UNITED STATES
NUCLEAR REGULATORY COMMISSION
WASHINGTON, D.C. 20555-0001

MASSACHUSETTS INSTITUTE OF TECHNOLOGY

AMENDMENT TO AMENDED FACILITY OPERATING LICENSE

Amendment No. 31
License No. R-37

Figure 6.6.1.1-1 Fission Converter Safety Limits for Forced Convection.
(for either ten or eleven fuel elements)

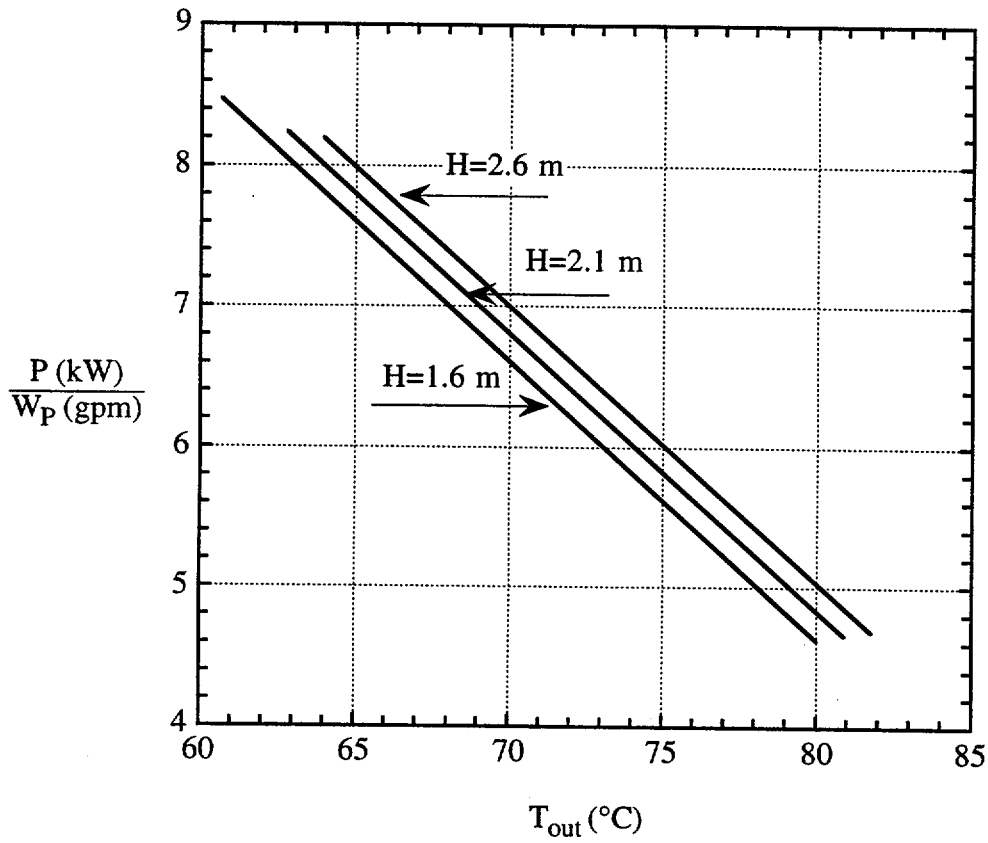
1. For forced convection, the point determined by the true values of P , W_p , and T_{out} shall not be above the line given in Figure 6.6.1.1-1 corresponding to the coolant height, H .
2. For natural convection, the coolant height shall be at 2.4 m or higher and the point determined by the true values of P and T_{mix} shall not be above the line given in Figure 6.6.1.1-2.

OSV was calculated in the Fission Converter Safety Evaluation Report (SER) for the hot channel. Uncertainties because of departure from nominal design specifications, measurement errors, and use of empirical correlations are taken into account in these calculations. The safety limits were evaluated based on the limiting core operating conditions described in TS# 6.6.2.1. Figure 6.6.1.1-1 shows the calculated fission converter safety limits for forced convection for three coolant heights: 2.6 m, 2.1 m, and 1.6 m above the top of the fuel elements. This figure is applicable to either ten or eleven fuel elements.

Figure 6.6.1.2-1 Calculated Results for the Fission Converter LSSS for Operation with Forced Convection. (for either ten or eleven fuel elements)

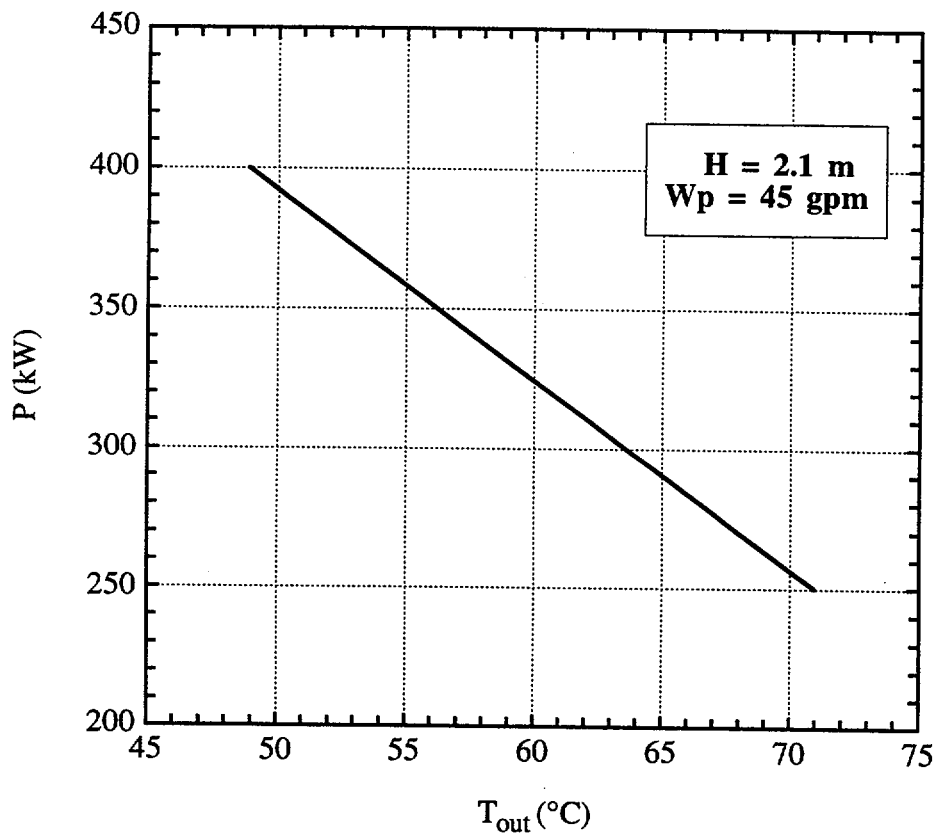
Figure 6.6.1.2-1 shows the result of the fission converter LSSS calculations for a primary coolant flow rate of 45 gpm and a coolant height of 2.1 m for operation with

forced convection. The LSSS temperature calculated for 300 kW is 63°C, and hence a primary coolant outlet temperature setting of 60°C is conservative.

Figure 6.6.1.2-2 Fission Converter LSSS for Operation with Natural Convection
(for eleven fuel elements only)

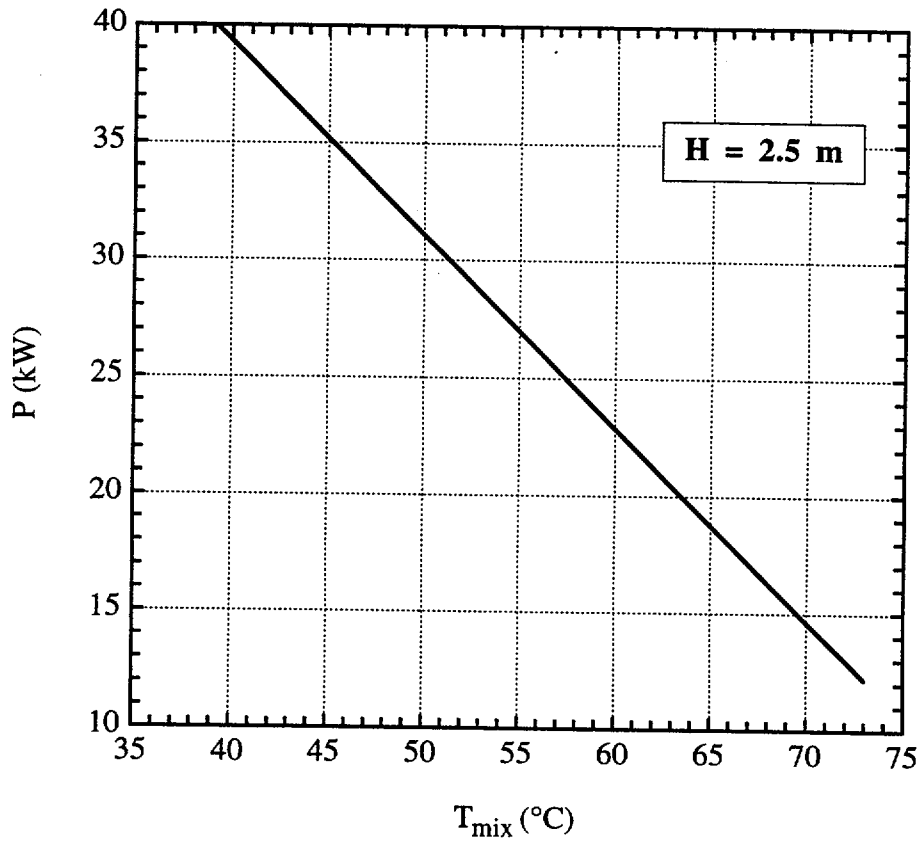
For fission converter operation with natural circulation, calculations have shown that the prediction of ONB coincides with that of OSV because of the low flow rate. Therefore, a 5°C margin is added to the safety limit curve to establish the LSSS. This 5°C margin corresponds to about 6 minutes of heat up time in the mixing area with the fission converter at 20 kW and thus provide adequate response time for corrective actions. The resulting LSSS curve is shown in Figure 6.6.1.2-2. The LSSS for fission converter operation with natural circulation is conservatively determined for a maximum power of 20 kW and a maximum coolant mixing temperature of 60°C with a coolant height of 2.5 m.
